## Wisconsin Department of Transportation

**Proposal #08: 5025-00-72, WISC 2026128**  
**T Tomah, Interior Road**  
**Lemonweir Creek Bridge, B-41-0339**  
**LOC STR**  
**Monroe County**

This is Addendum No. 01, which provides for the following:

Addendum No. 01  
ID 5025-00-72  
Revised Sheet 27  
January 8, 2026

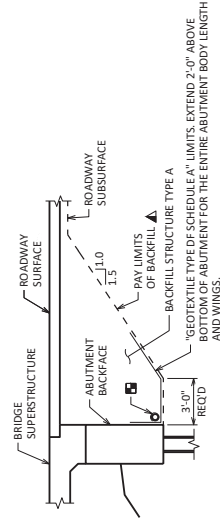
Revised Plan Sheets	
Plan Sheet	Plan Sheet Title (brief description of changes to sheet)
27	Structure Plan Sheet 2 – Total Estimated Quantities Table (rounded railing quantity)

513.40.61	RAILING TUBULAR TYPE M	LF	---	---	---	12
516.05.00	RUBBERIZED MEMBRANE WATERPROOFING	SF	---	6	6	12
550.00.20	PRE-BORING ROCK OR CONSOLIDATED MATERIALS	LF	---	70	70	140
